Item Name: Crosstube Turning Detail

DART AEROSPACE LTD		Work Order:	50695
Description: Crosstube Assembly (205/212/412 Low Fwd)		Part Number:	D212-664-147
Inspection Dwg: D212-664-147 Rev: A		Page 1 of 1

A		07.07.07	NEW ISSUE
DESIGN	gp	DRAWN BY	gp
COPYRIGHT © 2007 BY DART AEROSPACE LTD.		 DART AEROSPACE LTD. <small>HARNESSBURY, ONTARIO, CANADA</small>	
CHECKED	pt	APPROVED	pt
THIS DOCUMENT IS PRIVATE AND CONFIDENTIAL AND IS SUPPLIED ON THE EXPRESS CONDITION THAT IT IS NOT TO BE USED FOR ANY PURPOSE OR COPIED OR COMMUNICATED TO ANY OTHER PERSON WITHOUT WRITTEN PERMISSION FROM DART AEROSPACE LTD.		DRAWING NO.	REV. A
DATE	07.07.07	D212-664-147	SHEET 1 OF 3
		TITLE	SCALE
		CROSSTUBE (205/212/412 LOW FWD) NTS

DRAWING NO. D212-664-147	TITLE CROSSTUBE	REV. A	DART AEROSPACE LTD ENGINEERING ORDER		D.E.O. NO. D212-664-147-A-1	SHEET NO. SHEET 1 OF 1	SCALE NTS
DRAWN <i>(Signature)</i>	CHECKED <i>PA</i>	MFG. APPR. <i>E</i>	APPROVED <i>(Signature)</i>		DE APPR. <i>SH</i>		
DATE 09.05.01	DATE 09.06.15	DATE 09.06.15	DATE 09/06/16		DATE 09/06/16

FIGURE 1 - SUPPORT INSTALLATION

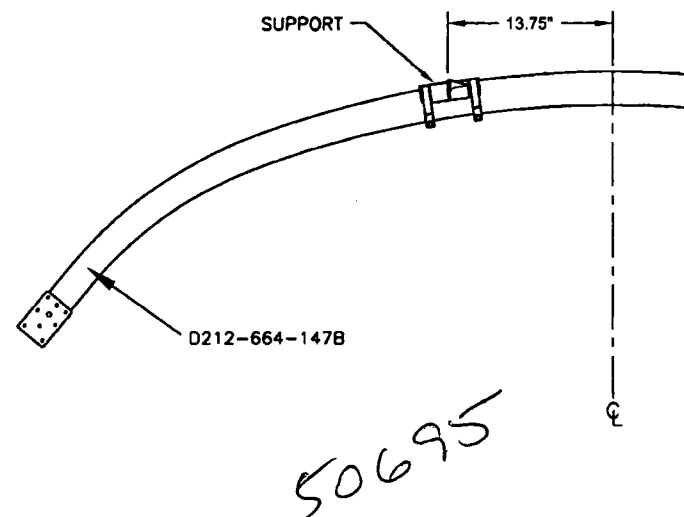
ADD THE FOLLOWING CROSSTUBE ASSEMBLY:

Part Number	Description
D212-664-147B	CROSSTUBE ASSEMBLY (214 LOW FWD)

THE D212-664-147B CROSSTUBE HAS THE SAME PARTS LIST AS THE D212-664-147 CROSSTUBE. HOWEVER, INSTALL THE SUPPORTS AS SHOWN IN FIGURE 1 OF THIS ENGINEERING ORDER. THE NEW KIT IS OTHERWISE ASSEMBLED PER THE D212-664-147 CROSSTUBE.
